# Access Compliance Report

## Public Rights-of-Way

Intersection ID: 24455	Main Street: S_TRYON_ST	Cross Street: STEELE_CREEK_RD	Location: NE
ADA ID: 19595BA89807	Ramp Type: Perp	Initial Pass/Fail: Pass	Overall Compliance: No
Severity Score: 5.25			
Codes/Mitigation Info/Possible Solution		Field Measurements/Component Compliance

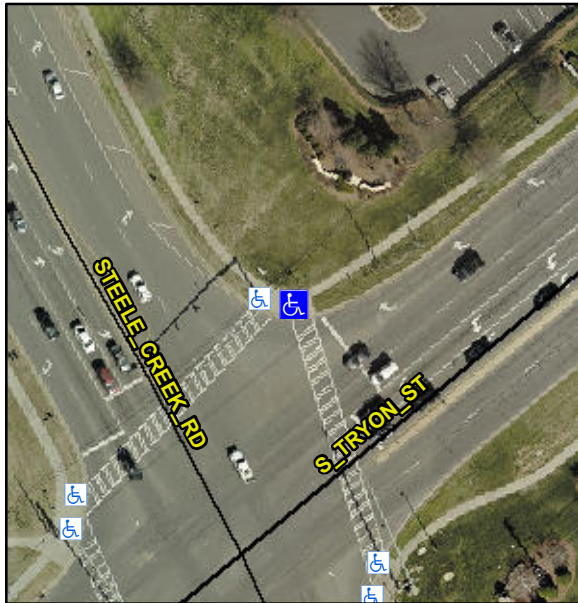
**R304.5.3, R304.2.2-Perp, R304.3.2-  
Para, R302.7, R304.5.4**

Compliance	Description	Data	Compliance	Description	Data
N/A	Ramp Length (in)	93.0	Yes	Ramp Slope (%)	5.8
Yes	Ramp Width (in)	48.0	No	Ramp XSlope (%)	3.8
N/A	Flare Type LT	Sloped	N/A	Flare Type RT	N/A
N/A	Flare Slope LT (%)	8.8	N/A	Flare Slope RT (%)	11.6
N/A	Flare Traversable LT?	Yes	N/A	Flare Traversable RT?	No
Yes	Landing Length (in)	48.0	Yes	DWS Provided?	Yes
Yes	Landing Width (in)	48.0	Yes	DWS Contrast?	Yes
No	Landing Slope (%)	4.4	Yes	DWS Length (in)	24.5
No	Landing X Slope (%)	3.5	Yes	DWS Full Width?	Yes
N/A	Landing Curb? (Y/N)	No	Yes	DWS Offset (in)	0.0
N/A	Shared Landing?	No			
No	Gutter Ponding?	Yes	No	Gutter Slope (%)	5.8
Yes	Gutter Lip Ht (in)	0.0	Yes	Gutter X Slope (%)	0.8
N/A	Painted X Walk1?	Yes	N/A	Painted X Walk2?	N/A
	X Walk 1 Direction	To S		X Walk 2 Direction	N/A
N/A	X Walk 1 Width (in)	120.0	N/A	X Walk 2 Width (in)	N/A
	X Walk 1 Slope (%)	3.7		X Walk 2 Slope (%)	N/A
	X Walk 1 X Slope (%)	0.2		X Walk 2 X Slope (%)	N/A

**Remove & Replace Entire Ramp.  
Remove & Replace Gutter.**
